ISLAM GARMENTS LTD. (UNIT-2)-Extension

ZARUN, KONABARI, GAZIPUR
(23.994929, 90.326208)

28th April 2019

Typical floor layout plan

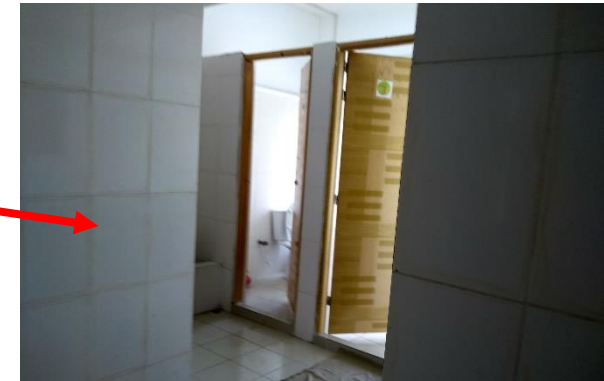
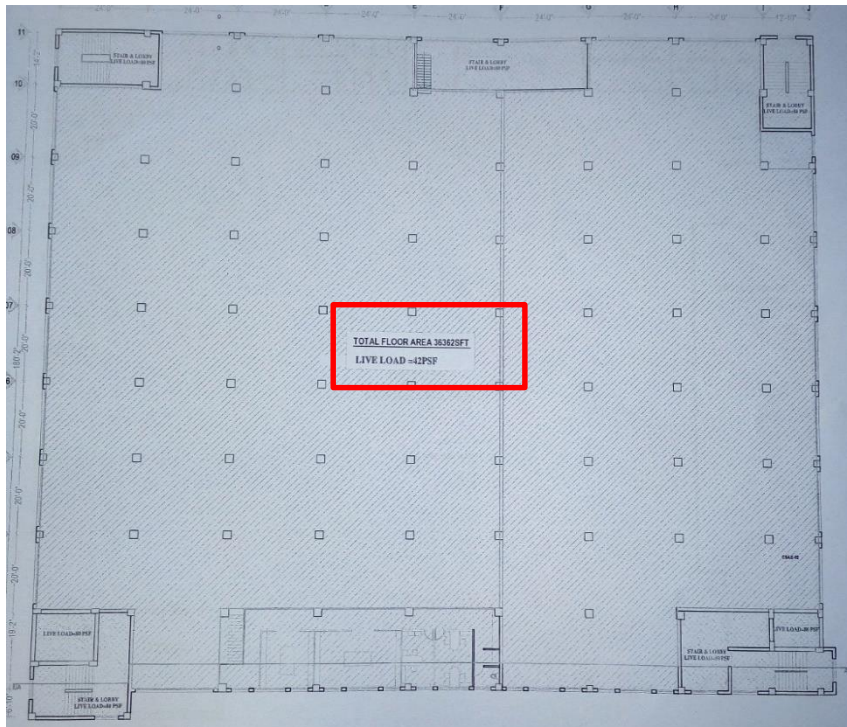
**Column stresses marginally exceeds the
normal design limit**

Cursory calculation indicates that columns appear to be stressed marginally above normal design limits considering floor built up loads (Toilet zone), 3kPa live loads on typical floor and assuming minimum concrete strength. Building Engineer to review design, loads and columns stresses.

Floor load plan

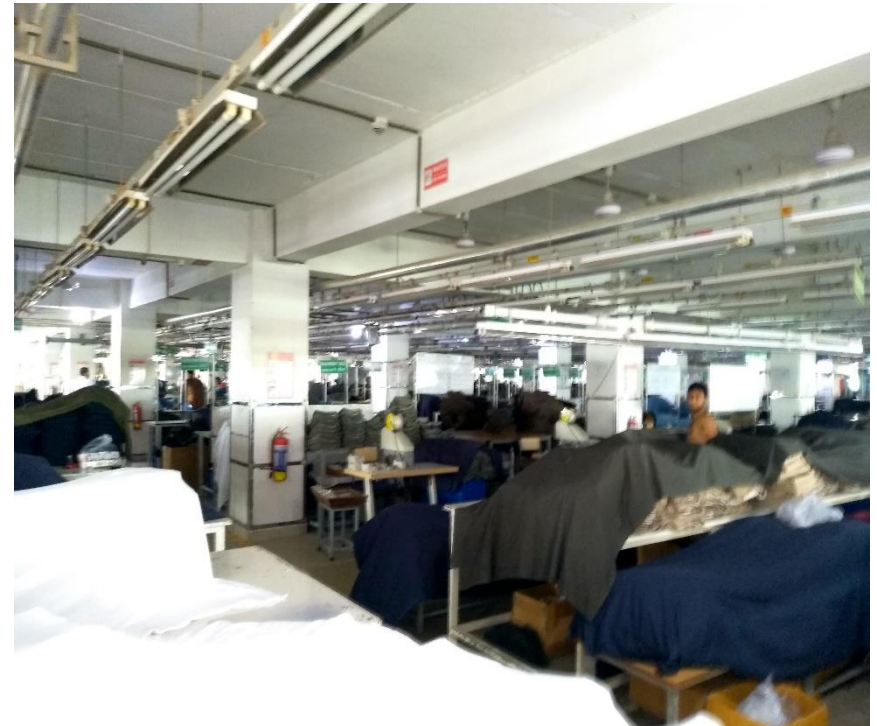
Floor loading condition (Within 3 kPa)

The construction of the building was completed in December 2018. Therefore, as per BNBC standard load plan of the building is required to be considered minimum 3 kPa. But the load plan provided by the factory considers 2 kPa. Factory is required to revise the load plan considering BNBC standard and implement the load plan accordingly.
